Access Compliance Report

Public Rights-of-Way

(Pedestrian Signals)

Intersection ID: N/A	Main Street:	Cross Street: N/A	Location: N/A
ADA ID: 25B9BC736646	Signal Type: One Push Button-Non APS	Overall Compliance: No	Severity Score: BTN 1: N/A BTN 2: N/A No BTN: N/A
Codes/Mitigation Info/Possible Solution		Field Measurements/Component Compliance

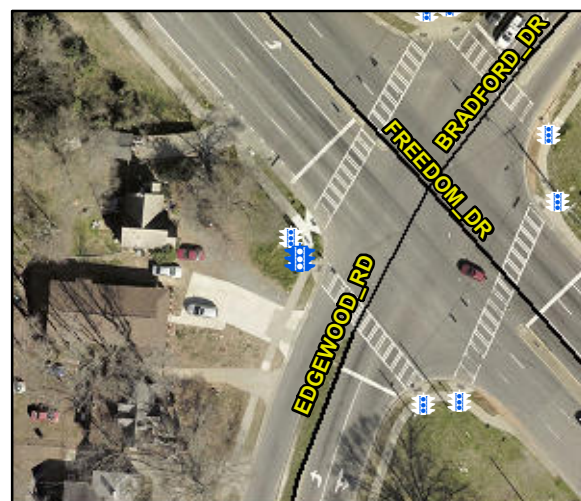
PROW/ADA: TMUTCD 4e.08, R404.7.2

N/A	B 1 Clear Xing Direction?	Yes	N/A	B 2 Clear Xing Direction?	N/A
	B 1 Crossing Direction	To SE		B 2 Crossing Direction	N/A
Yes	B 1 DistanceTo XWalk (in)	0.0	N/A	B 2 DistanceTo XWalk (in)	N/A
No	B 1 DistanceTo Curb (in)	124.0	N/A	B 2 DistanceTo Curb (in)	N/A
Yes	B 1 Diameter (in)	2.0	N/A	B 2 Diameter (in)	N/A

Possible Solutions: Replace Signal Push Button With APS Button on New Post. Remove & Relocate Sign.
